RIOCAN – WINDFIELDS FARM BLOCK C2: RFP – ADDENDUM NO.03

ADDENDUM NO.3 ISSUED: August 1st, 2023

Project Name:	Windfields Block C2	Date:	2023-08-01
Address:	Winchester Road & Simcoe Street, Oshawa, ON	Addendum No.:	03
		Proj. No.:	08.118CS3

Project Name:	Windfield Farms Block C	Issued Date:	August 1, 2023
Project Address:	WINCHESTER ROAD & SIMCOE STREET OSHAWA, ONTARIO	M ADD No.:	2
Issued By:	Rishard Ragoonanan Dan Joffe	Architect:	Turner Fleischer
Project No.:	22-000-176	Attention:	Edward Uzoma

DRAWING
**SITE WATER METER ROOM & UTILITY
ROOM ENLARGED VIEW - PD**

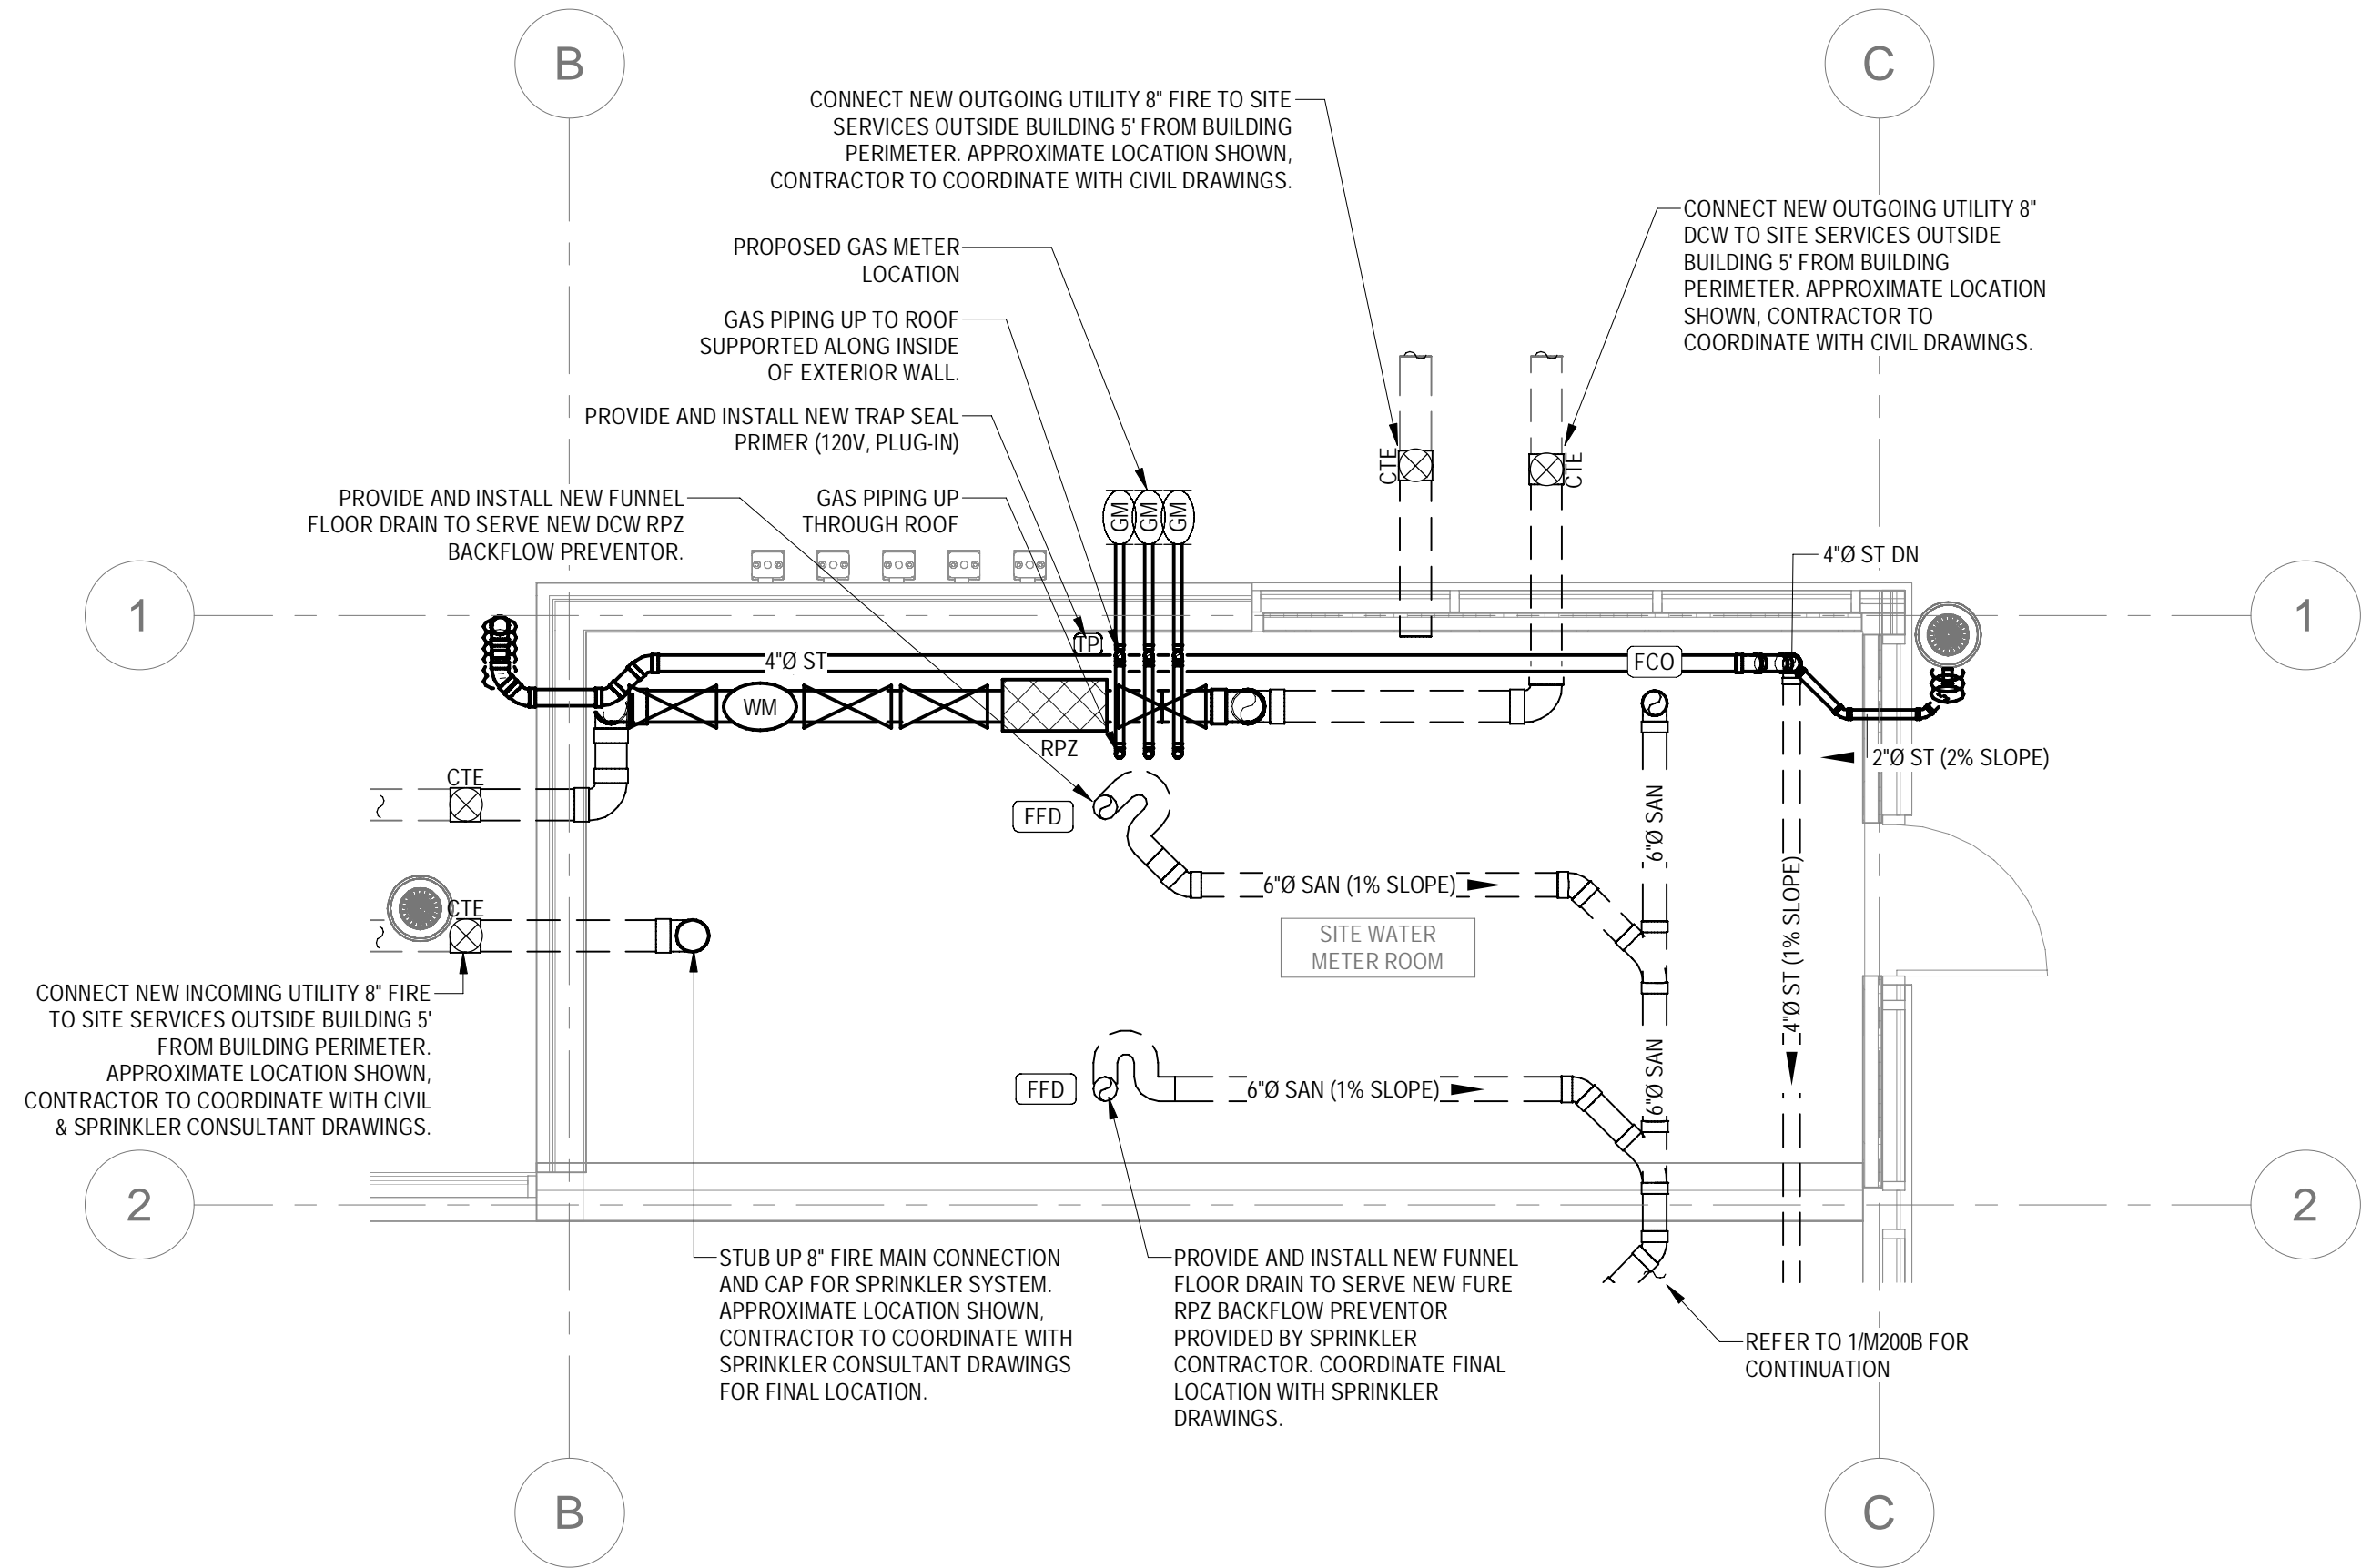
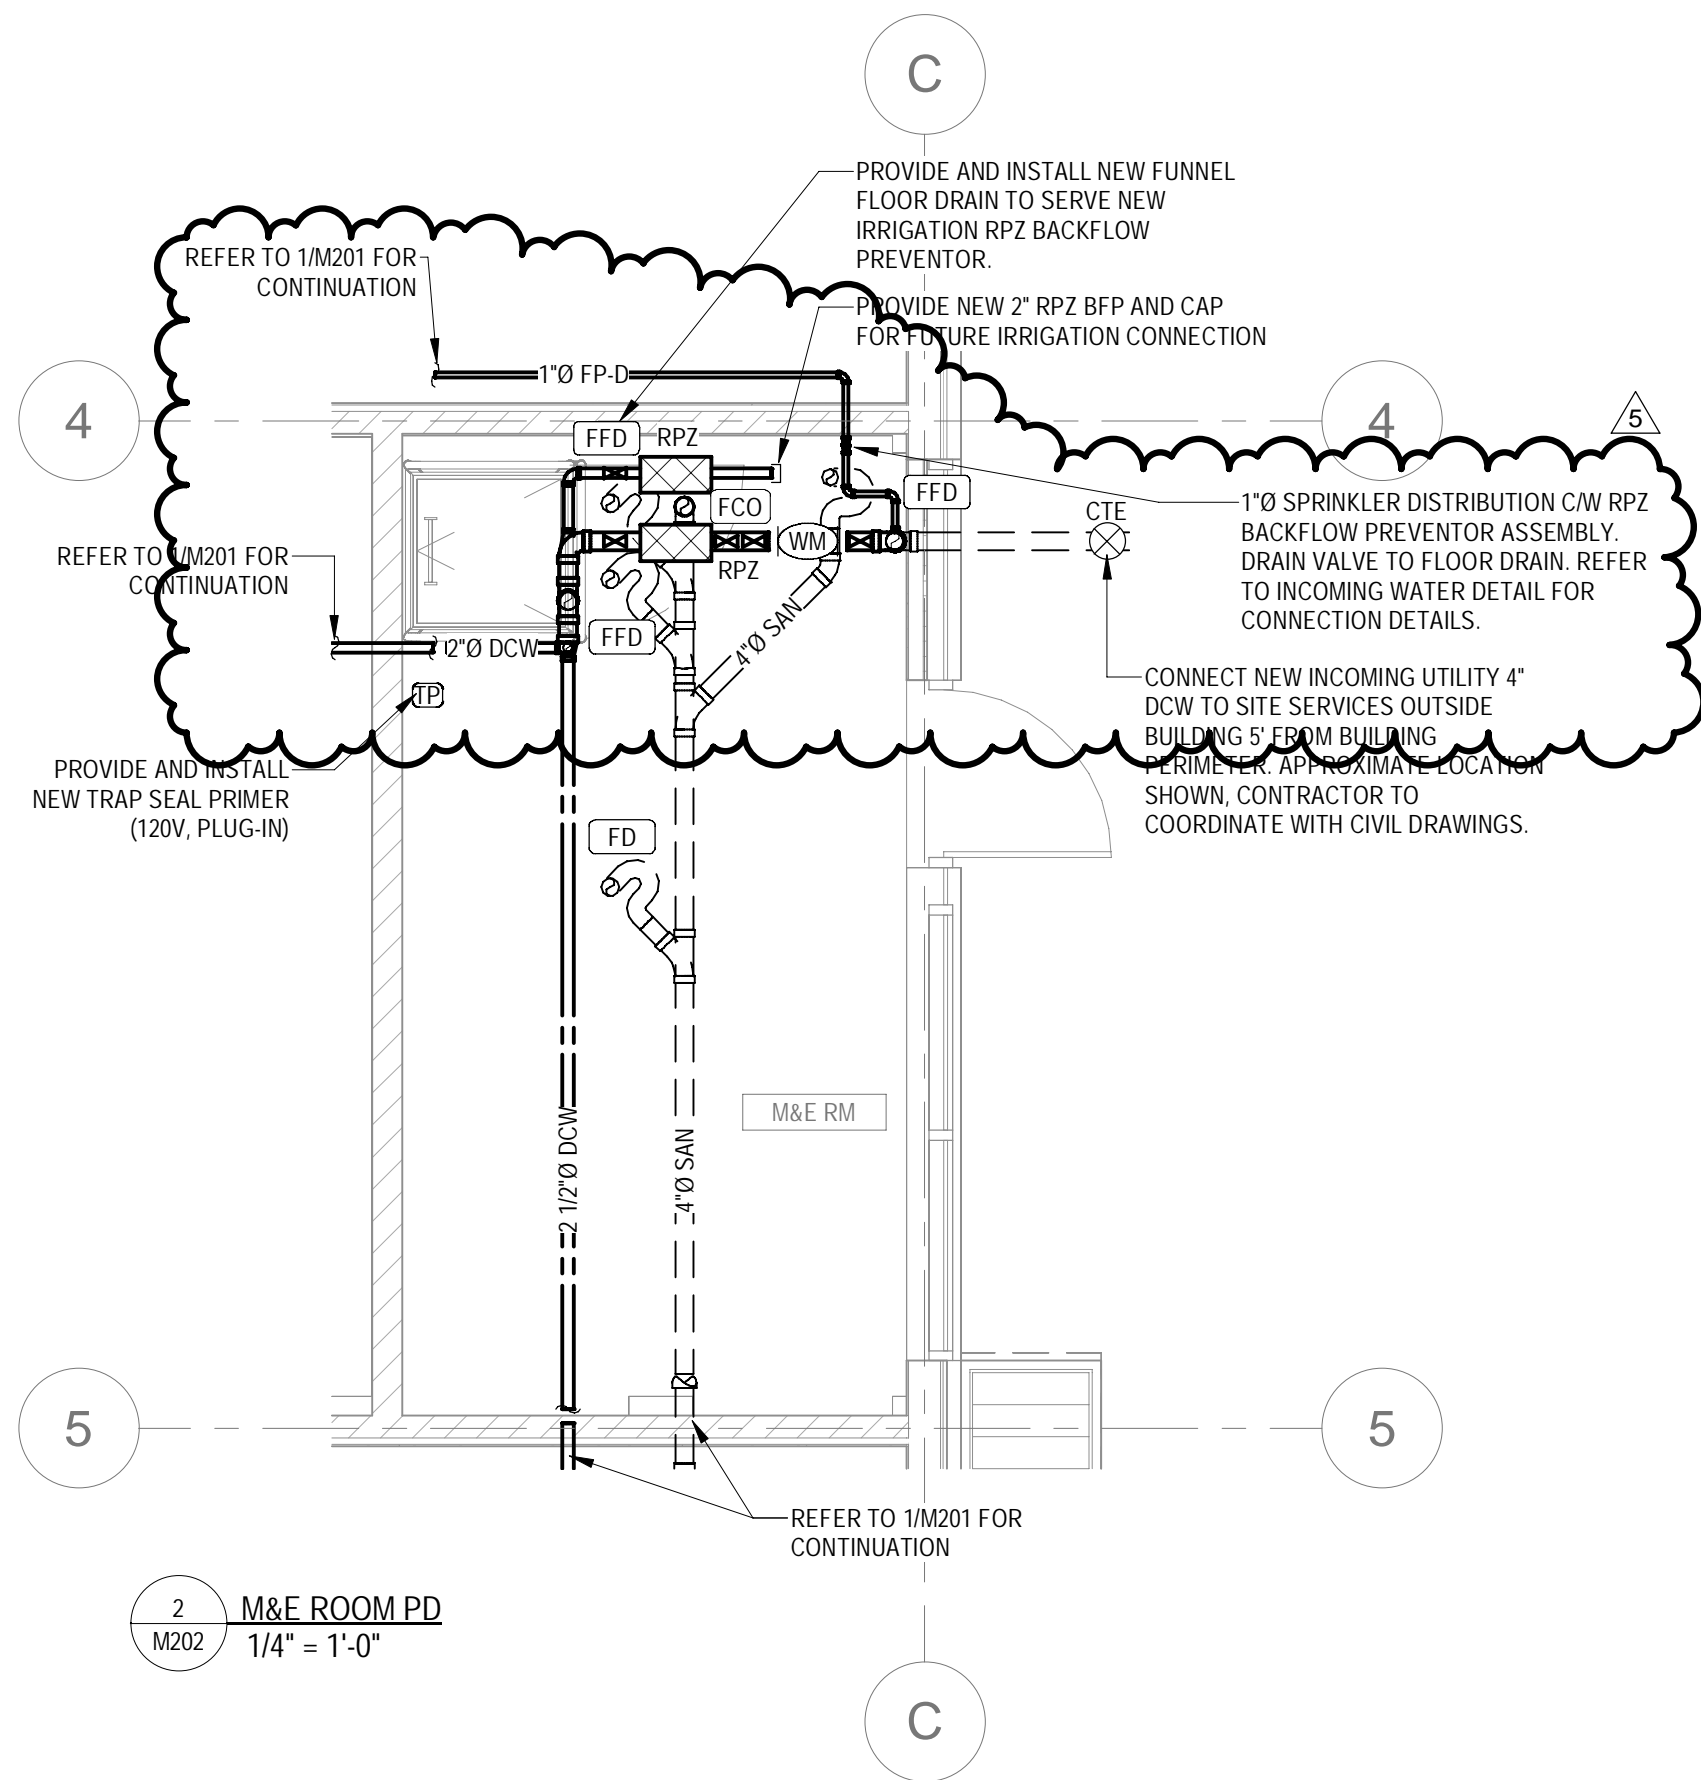
- 5.1. Addition of sprinkler distribution and funnel floor drain to serve dry sprinkler in garbage room.
